Michael A. Berardi
Director
Service Engineering Operations
Ford Customer Service Division

SUBJECT: DEMONSTRATION / DELIVERY HOLD / DO NOT DRIVE – SAFETY RECALL 14S09
Certain 2014 Model Year F-150 Equipped with Electronic Power Assist Steering
Steering Gear Replacement

CERTAIN 2014 MODEL YEAR F-150 VEHICLES WITH ELECTRONIC POWER ASSIST STEERING — STEERING GEAR REPLACEMENT

FIGURE 1

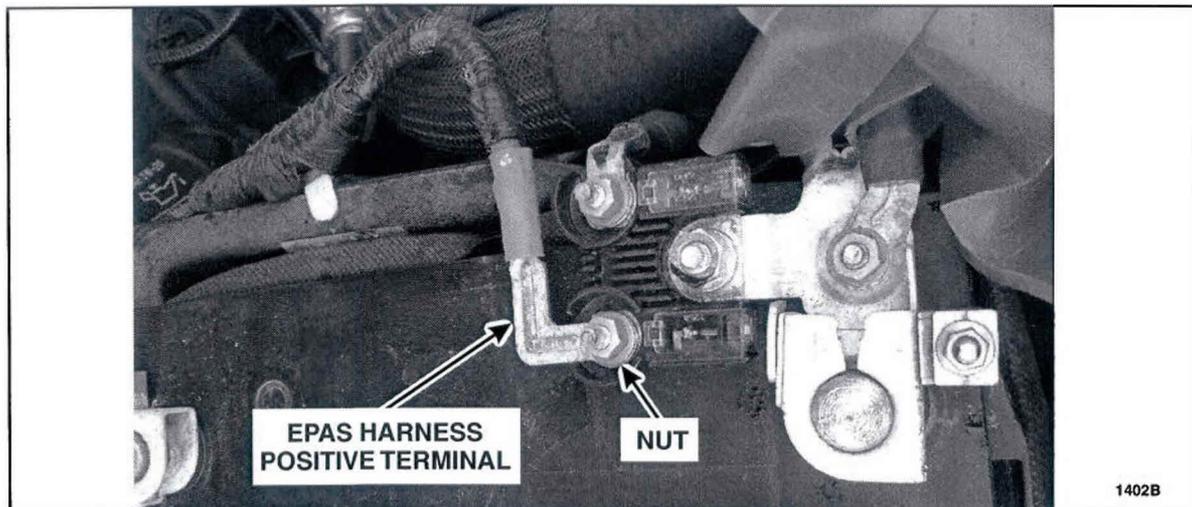
1. With the key in the OFF position, remove the EPAS harness positive terminal from the battery. See Figure 1.
 - a. Remove the nut from the EPAS harness positive terminal.
 - b. Remove the EPAS harness positive terminal from the battery.
 - c. Tape the exposed end of the EPAS harness positive terminal and secure the harness away from the battery to prevent contact with battery voltage.

1. Once in the service bay, reconnect the EPAS harness positive terminal to the battery prior to module configuration. See Figure 1.
 - a. With the key in the OFF position, install the EPAS harness positive terminal onto the battery.
 - b. Install the nut onto the EPAS harness positive terminal.
 - Tighten nut to 9 Nm (80 lb-in).
2. Replace the steering gear. For additional information, refer to Workshop Manual (WSM) Section 211-02.
